CALCULATOR SERVICE BULLETIN #P2-501

MODELS 211PC192 & 211PC193

PARTS CATALOG

This is the first of a series of supplements to the 'PC' Parts Catalog which will keep Service Departments advised of revisions and improvements as they are made in production. Catalog corrections and additions will also be included in these supplements. Subjects are identified by item numbers for reference purposes. Change in Design (C.D.) numbers are provided for Orange reference.

FIELD REBUILDING OF SELECTORS

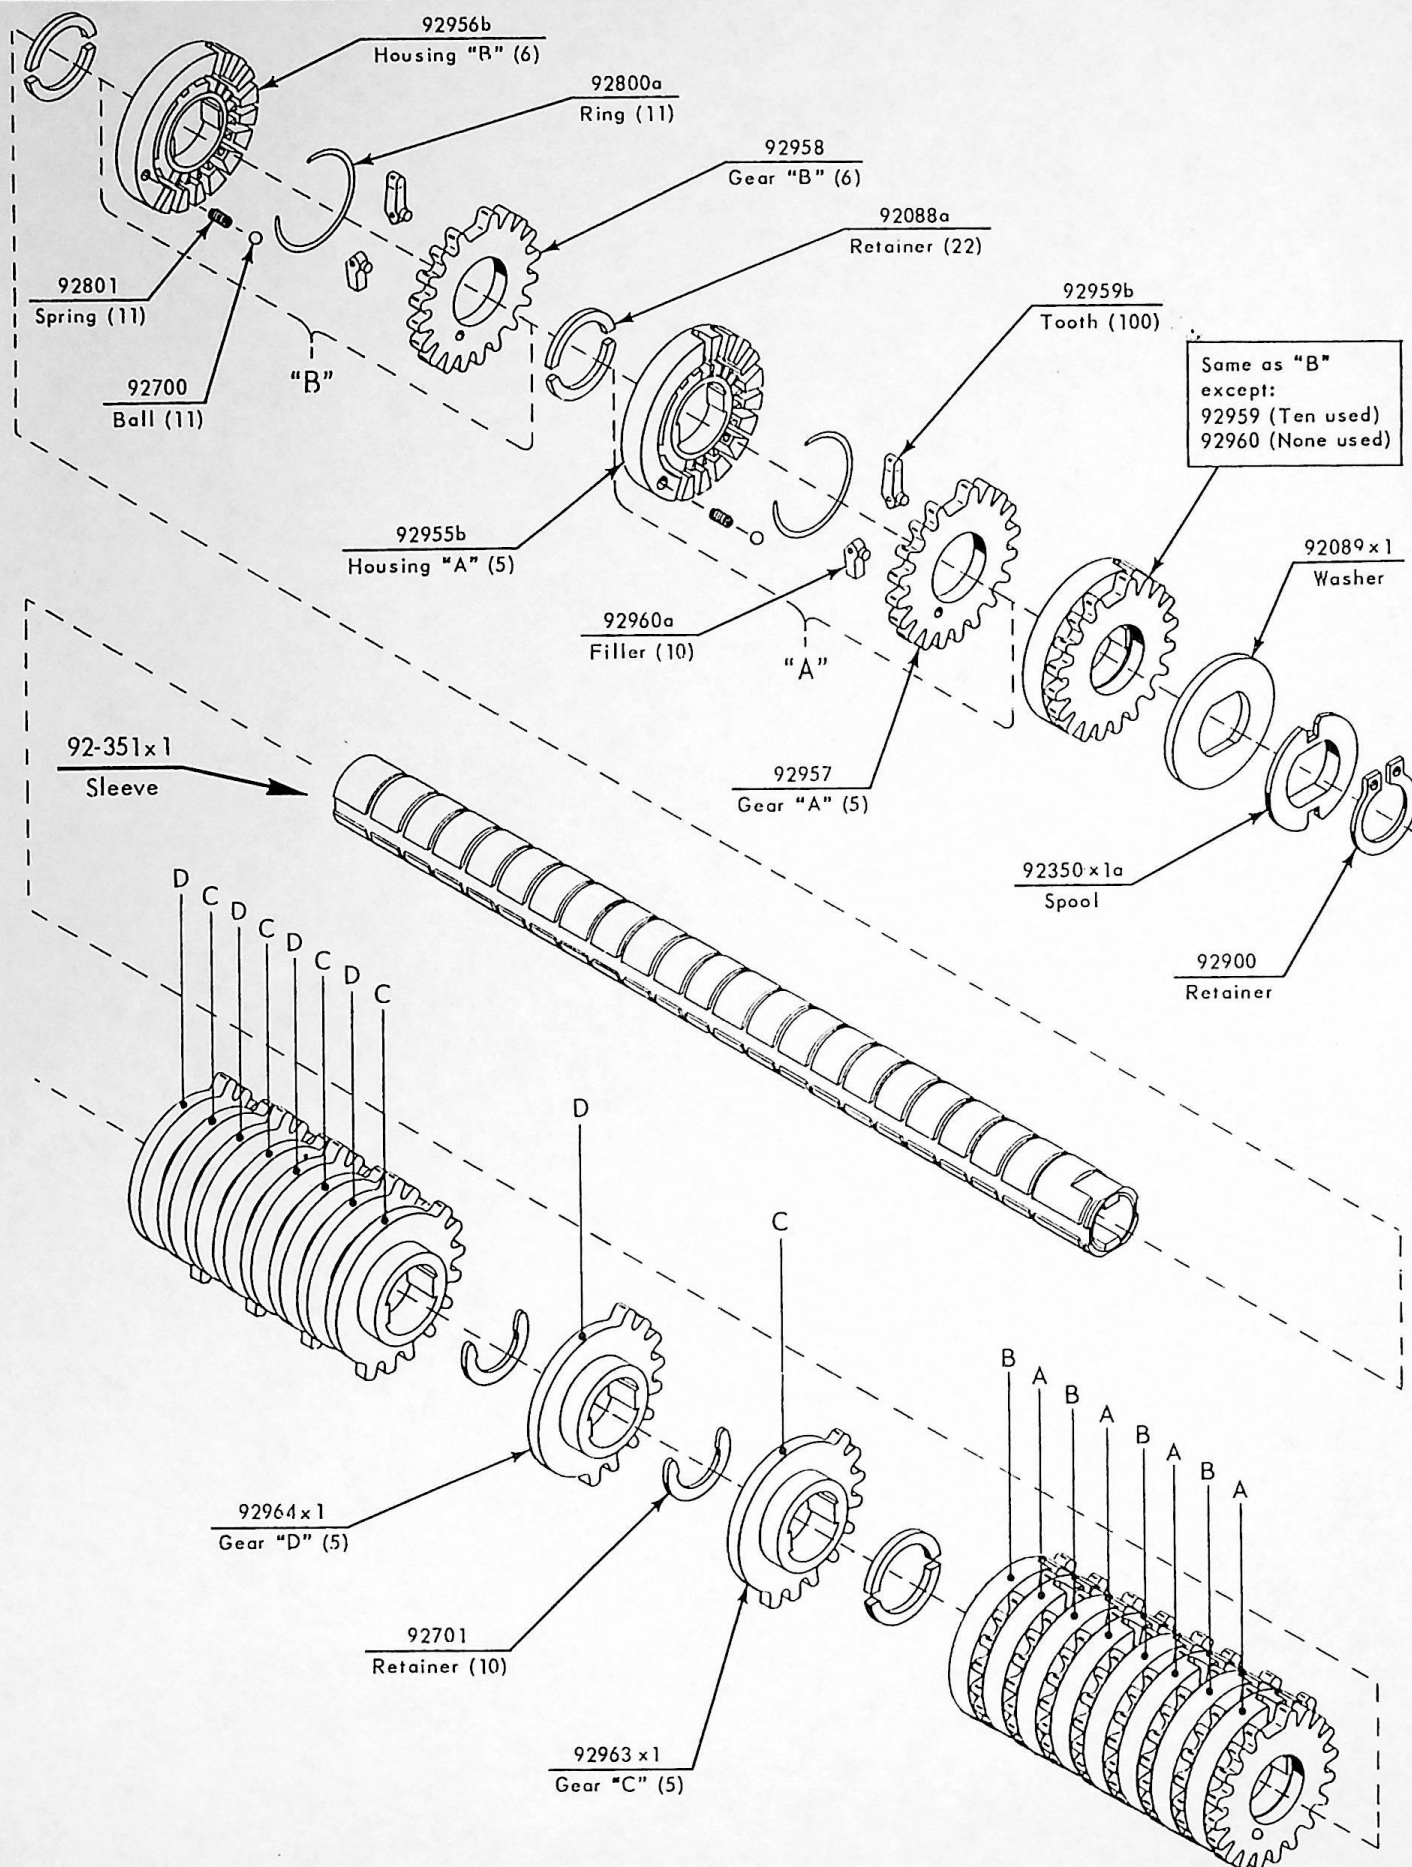
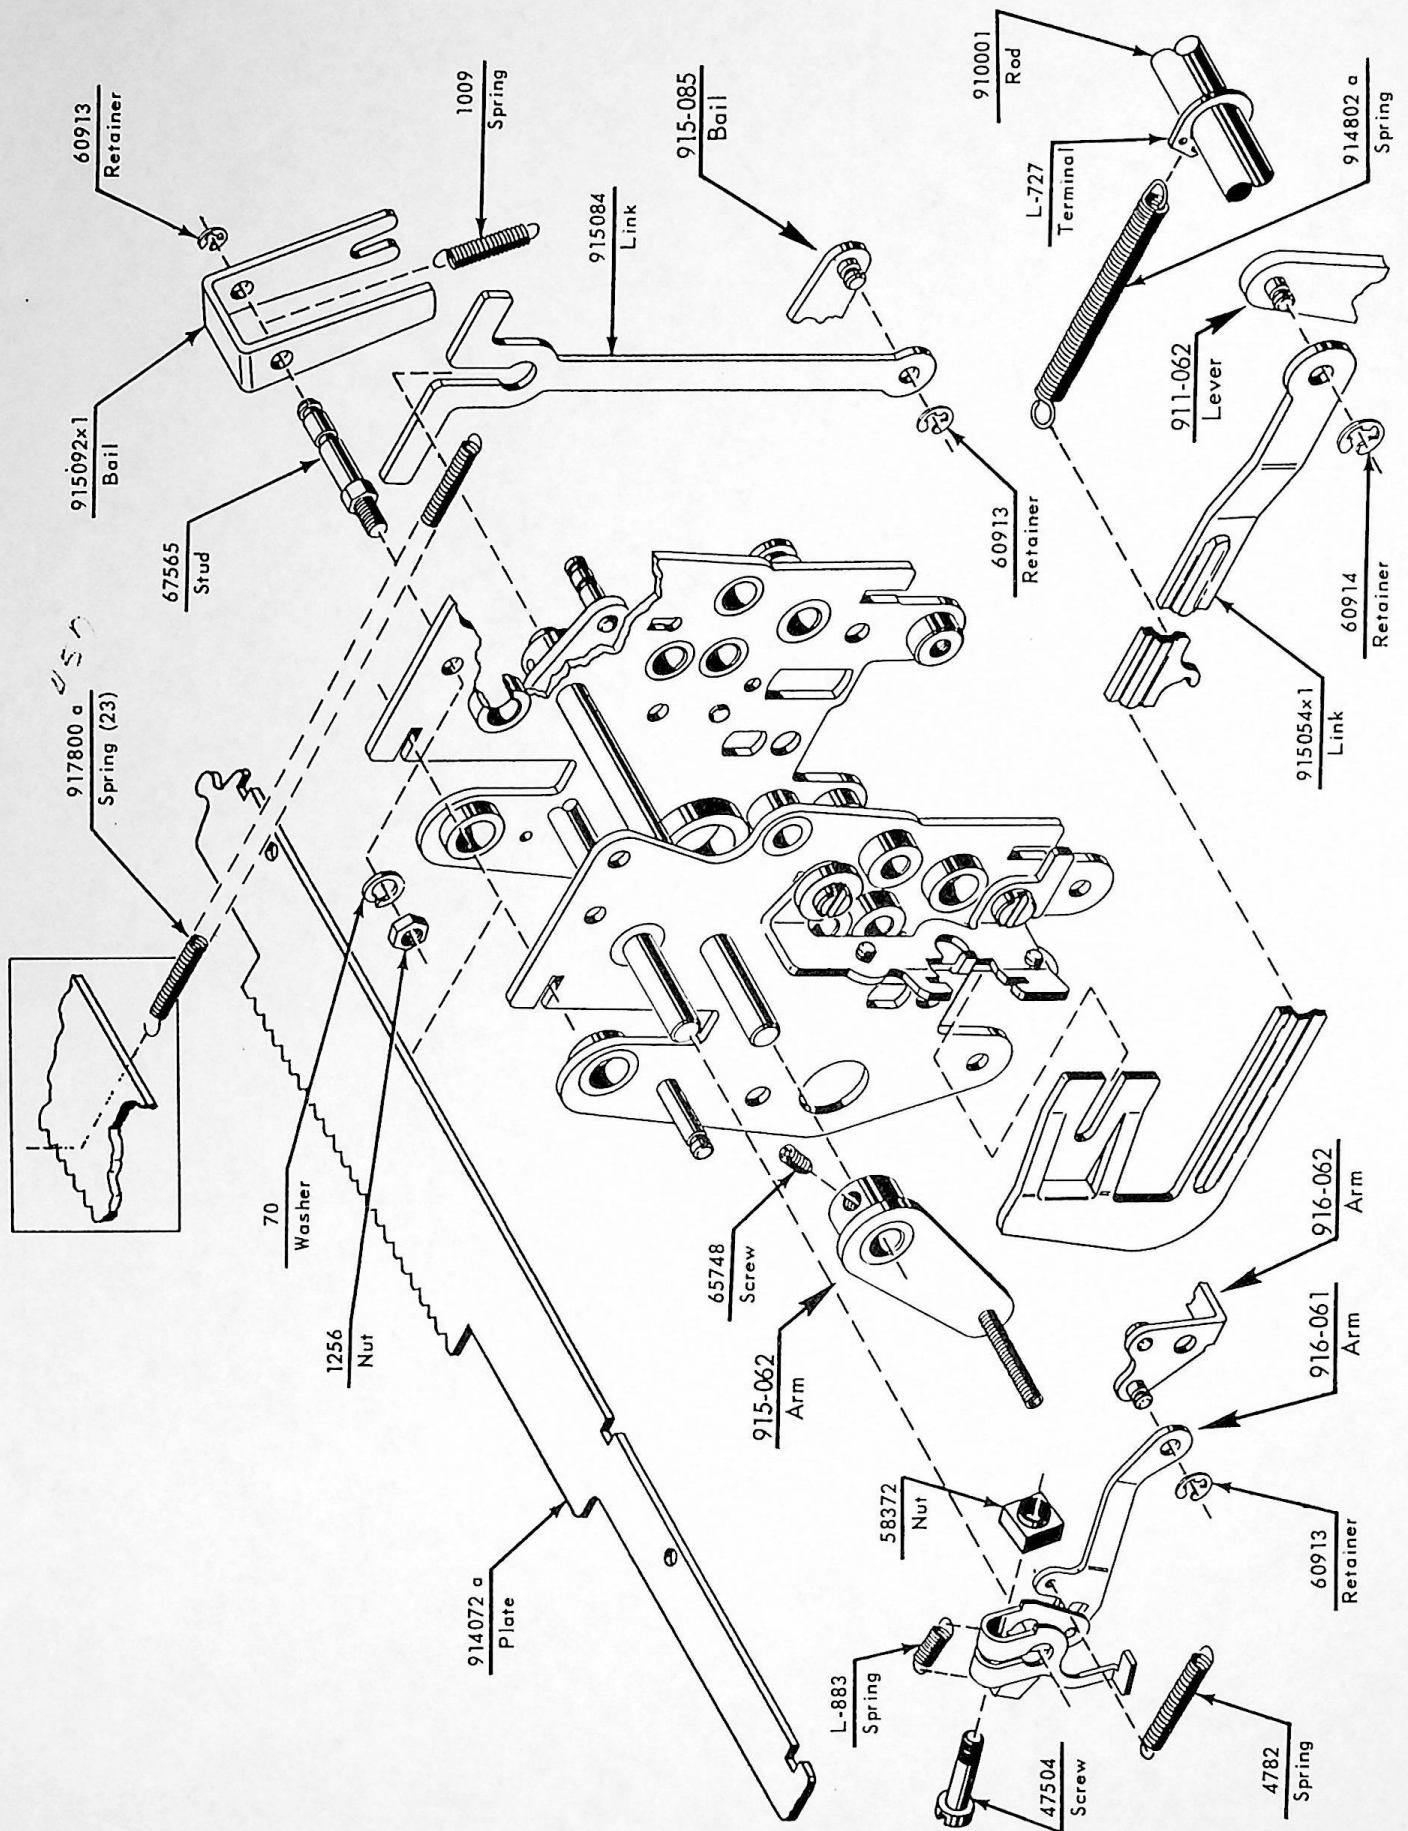
Zoning tolerances of selector assemblies are critical, therefore, special care should be exercised when disassembling and reassembling selectors.

ONLY BALL JOINT SELECTORS CAN BE REBUILT, (IDENTIFIED BY EITHER GREEN OR YELLOW DYKEM COLOR MARKING)

Note: Should a selector of previous design (non-ball joint) require replacement, a limited number of 92-2000x1 ball joint selector assemblies will be maintained in stock. However, requests for these will not be acknowledged unless the model and serial number are provided and the original non-ball joint selector accompanies the requisition. A charge will be processed for the replacement selector.

1. Identify by coloring the component requiring replacement.
2. Remove retainer #92900, spool disc #92350x1a, and washer #92089x1.
3. Carefully remove each setable gear assembly and locating retainers. Special care should be exercised that each assembly and retainer be set aside in the order of removal.
4. Replace broken tooth or component.
5. Reassemble the selector, being careful to locate each setable gear assembly and locating retainer into the same column position that it had been removed from.
